**ORDINANCE NO 2020-11**

**AN ORDINANCE TO REZONE AND ADOPT THE PRELIMINARY MASTER DEVELOPMENT PLAN FOR THE DISTRICT BEING LOCATED AT 108 STONEY CREEK ROAD, MAP 072P, PARCEL 028.00, 028.01, 028.02, 028.03 AND 028.04, IN THE CITY OF MT. JULIET, WILSON COUNTY, TN.**

## MEMORANDUM

**Re:** The District (Formerly Stoney Creek Town Center)  
PMDP  
Map – 72P  
Parcel- 28.00

# The District- PMDP Exhibit A

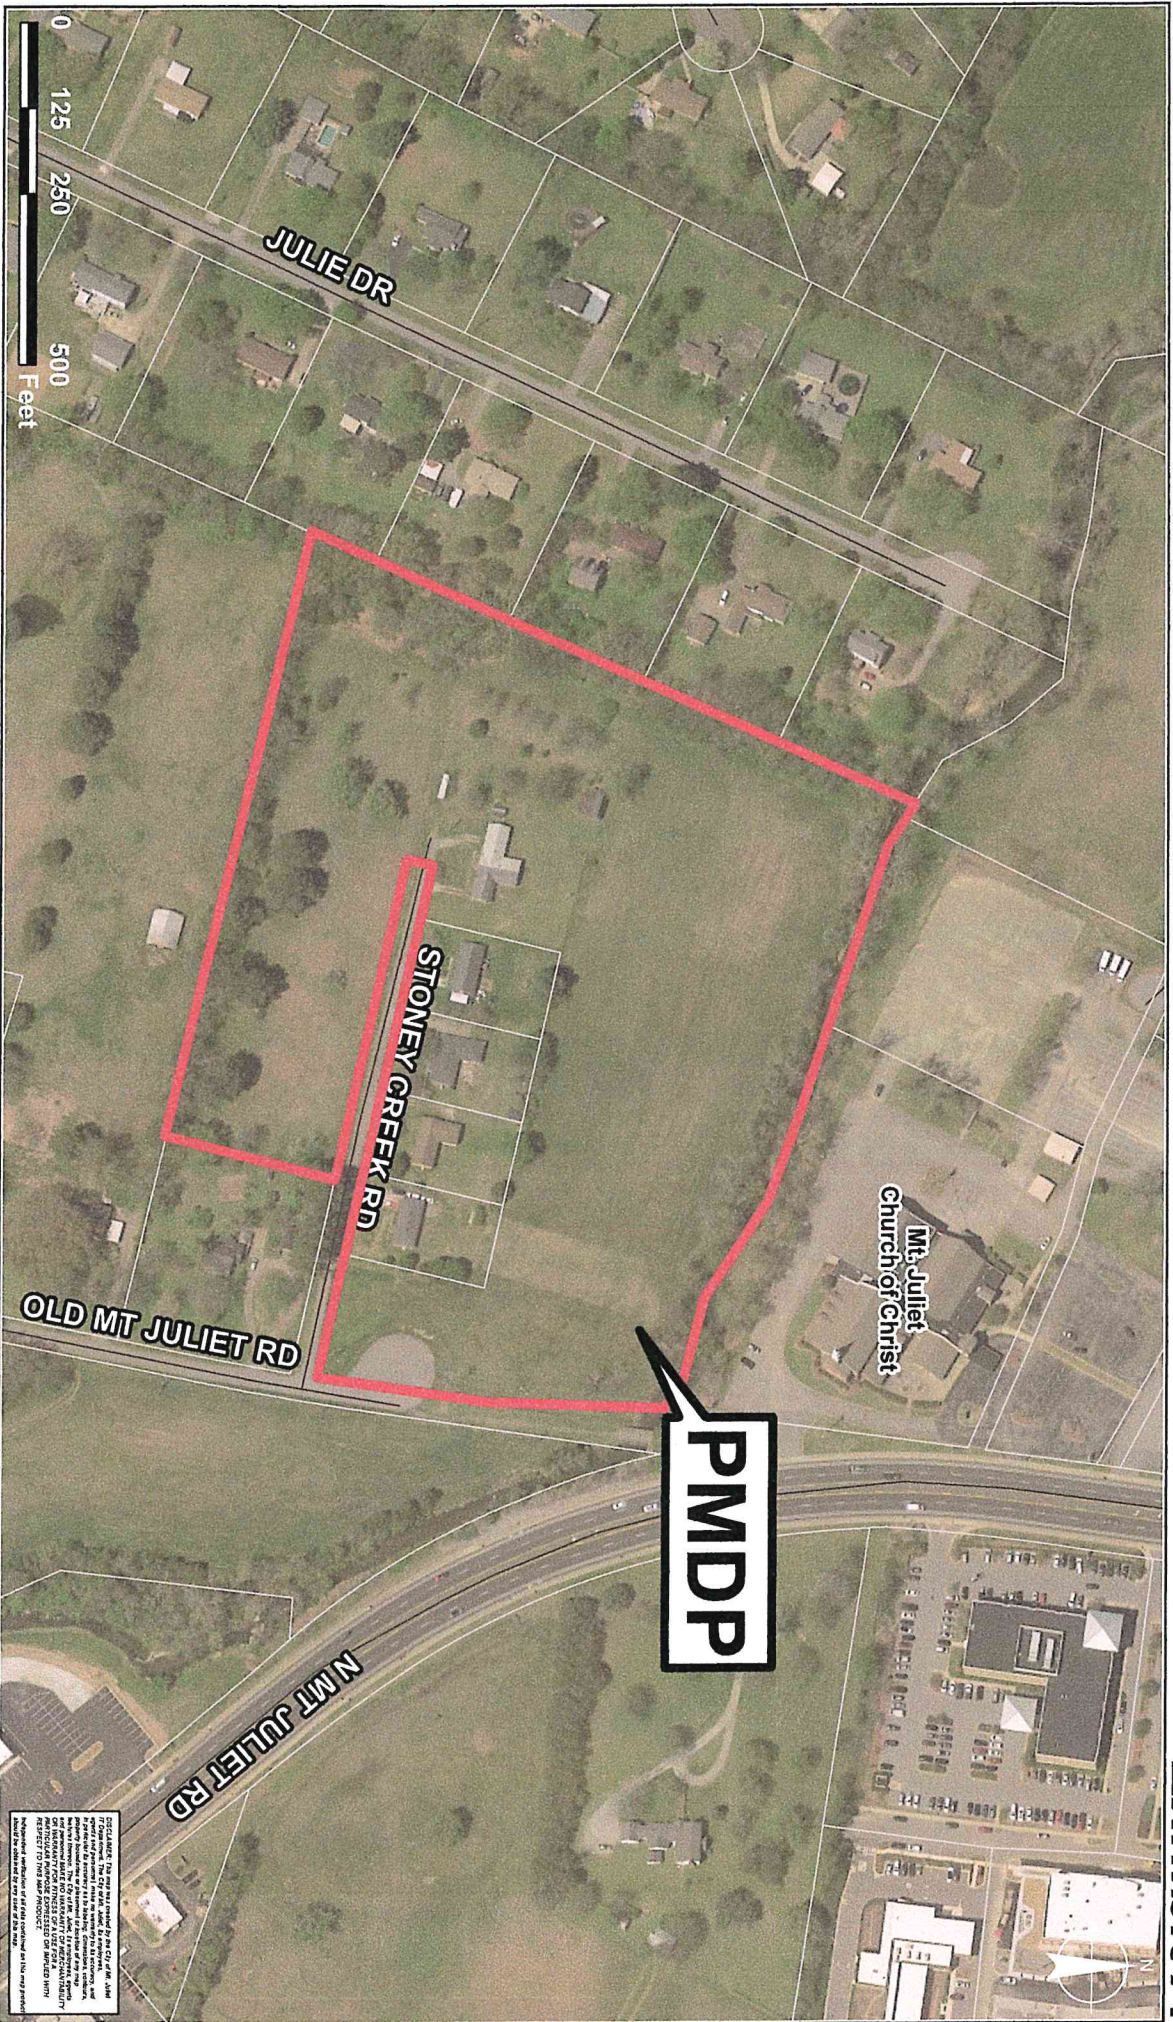
1. All Planning/Zoning comments are to be addressed before 1<sup>st</sup> Board of Commissioners meeting.
2. Staff does not recommend the layout for Units 62-74, 6-11 3, 30, 14, 14, 50, 51. Staff requests that a 22' driveway be provided for these units or on street parking in close proximity to the unit.

3. Clarify setbacks. The site data table and typical lot details do not match.
4. Correct the land use information in the table on C2-00.
5. The Planning Commission grants approval of the requested variances: 1.) to eliminate the required landscape buffer fence in the floodplain and; 2.) to permit a veterinary service on a lot which adjoins residential uses.

1. Stoney Creek Road shall be constructed to the City's Access Street standard with a 50 foot ROW.
2. Stoney Creek Road between Old Mt. Juliet Road and the roundabout shall be a public street. All other proposed streets shall be private.

3. Anywhere there is proposed perpendicular parking (18 foot parking stalls) the drive aisle shall be a minimum of 25 feet wide.
4. All 2 way traffic aisles to be a minimum of 22' wide.

5. When parking is adjacent to the sidewalk, sidewalk to be 7' wide minimum.
6. The developer has agreed to the following off-site improvements:
  - a. 5 foot wide sidewalk along the west side of Old Mt. Juliet Road from this site to Old Lebanon Dirt Road.

# The District- Rezone Exhibit C

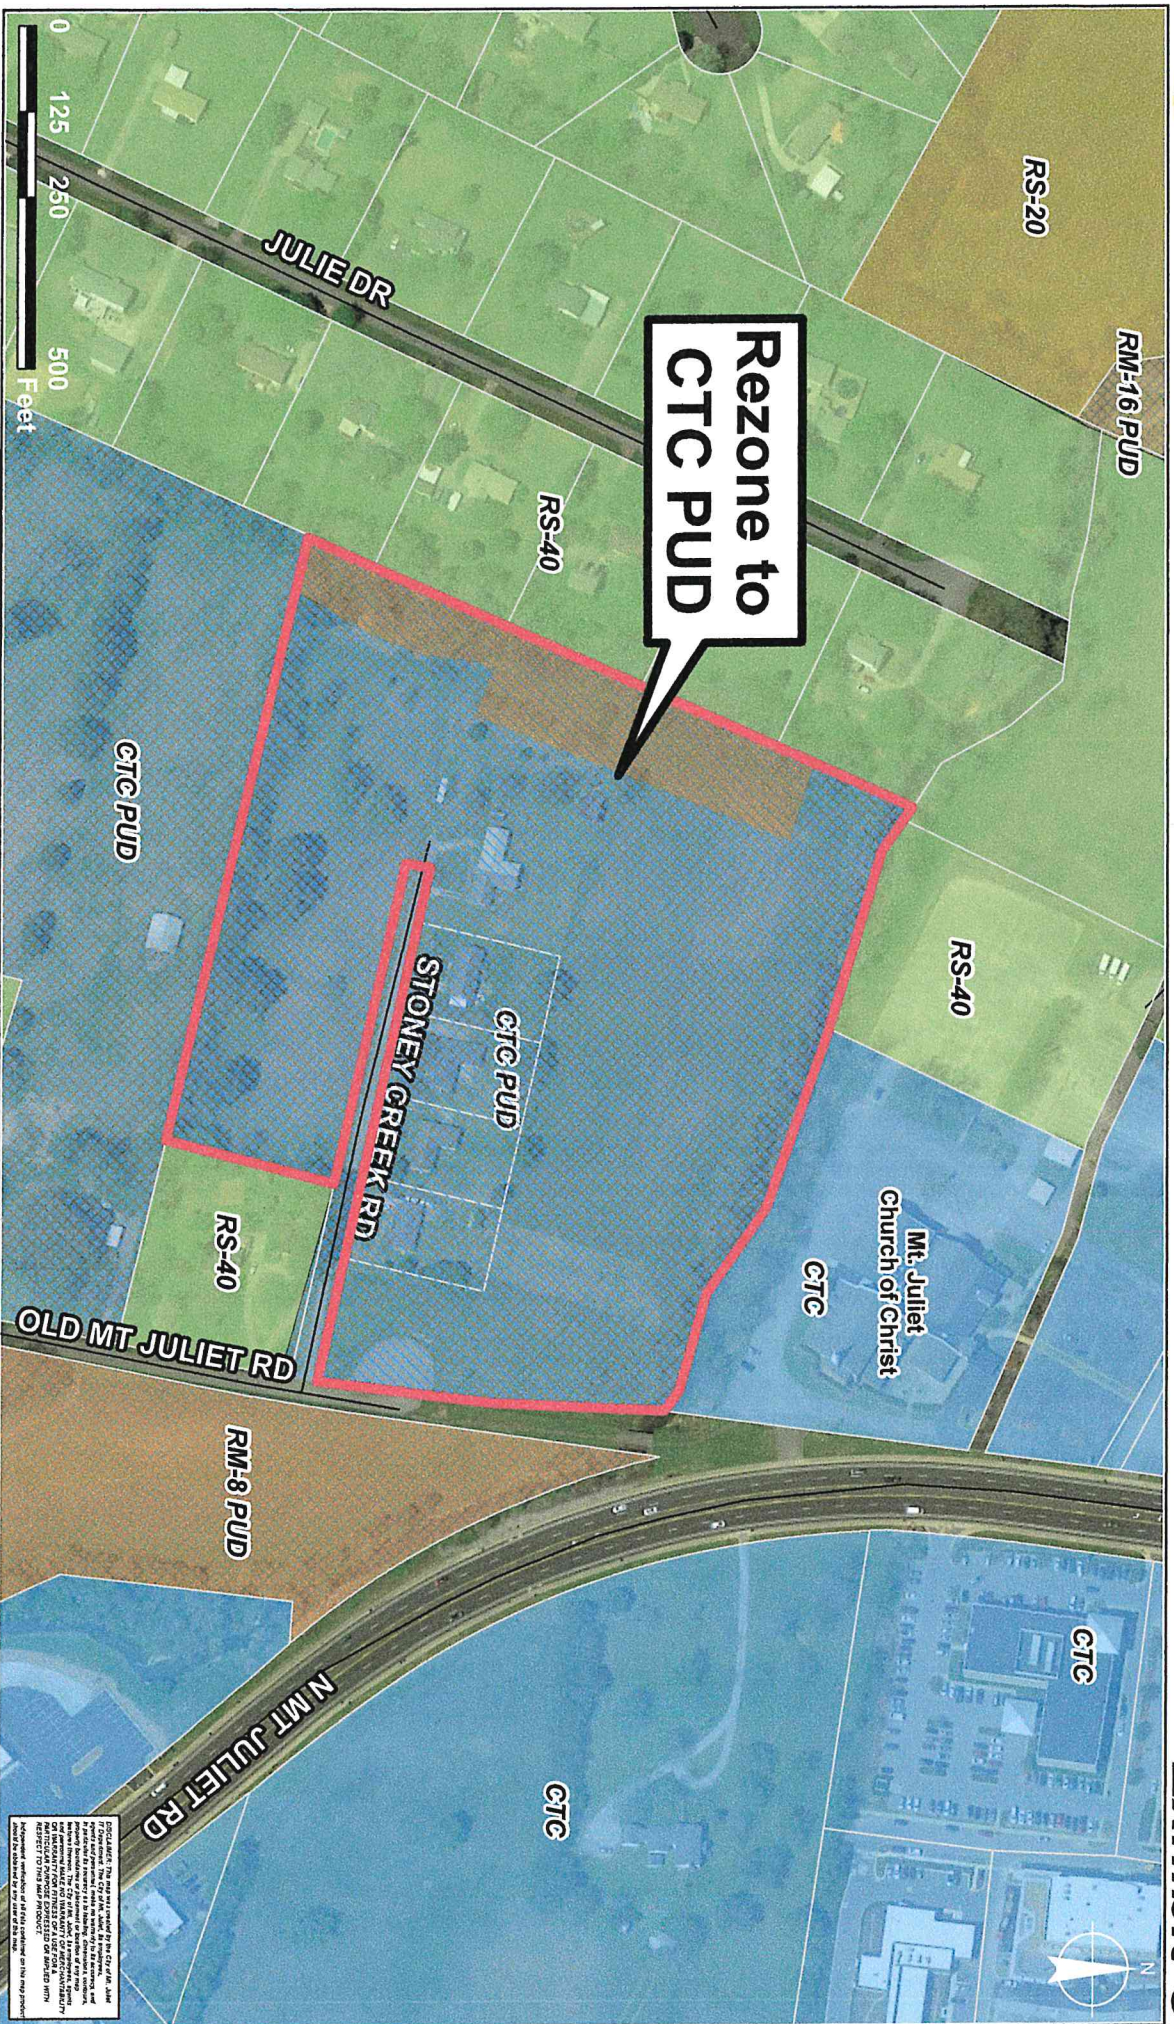
**SECTION 1.** – REZONING. Ordinance No. 2012-44 (Zoning Map), adopted July 23, 2012, be and is hereby amended, and altered by rezoning those certain parcels of real property in the The District property located at 108 Stoney Creek Road, described below and on Exhibit C dated January 9, 2020, (attached) RM-8 and CTC-PUD to CTC-PUD with the following conditions:
